# GLOBAL TECHNICAL BULLETIN

Ref No.: GTB2009016  
Date: September 16, 2009

**To: All Yanmar Marine Distributors**  
**Subject: Oil level change for SD50 series**

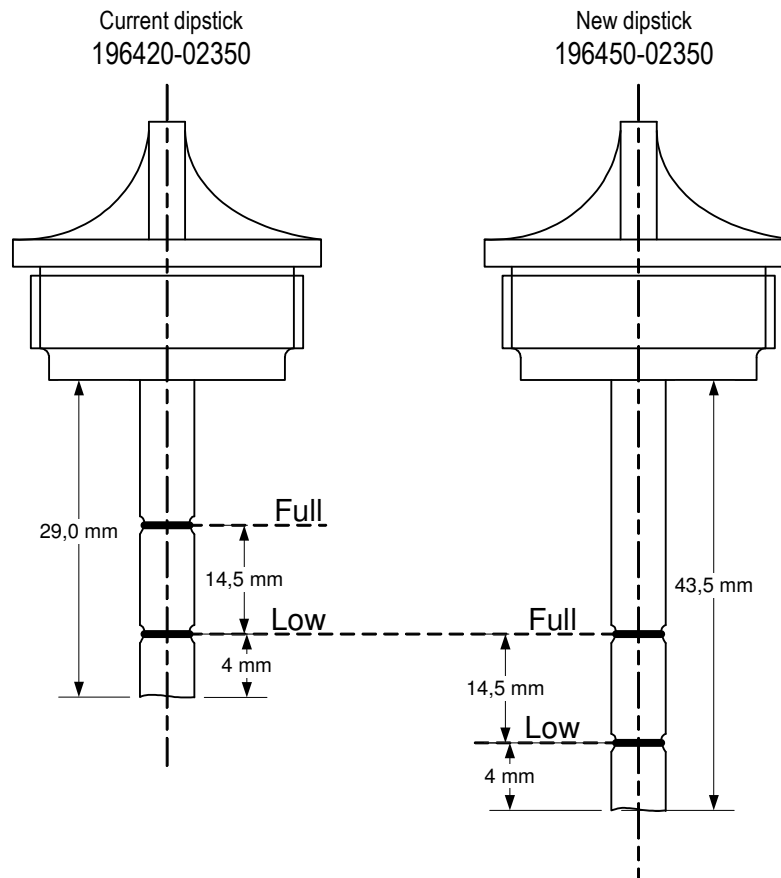
From our warranty-claim analysis, YMI has found some SD50 units with complaints regarding oil leakage at the input shaft, or where the oil was emulsified. YMI found that if our current oil-level is slightly exceeded, the inside pressure of the SD50 may exceed the proof leakage pressure for the oil seal. This can cause oil leakage at the input shaft during running, and it could suck water from the oil seal on the propeller shaft as well.

In order to obtain a lower oil pressure inside the drive, the maximum oil level has been changed from full position to low position on the dipstick.

[The difference is 14.5 mm on the dipstick]

The part number of the dipstick of the SD50 series has been changed from 196420-02350 to 196450-02350

- Please check the oil-level in the SD50 during regular maintenance.
- Correct the oil-level in the SD50 according to above specifications. If above newly recommended level; please remove oil to make the adjustment.
- If the oil-seal from the input-shaft or propeller-shaft is still leaking after correction of the oil-level, please replace the oil-seal.

**Remarks:** Dipstick is very short, so no possibility to put new low-level mark on current dipstick. Please use current low-level mark as new high-level mark for correct oil-level.
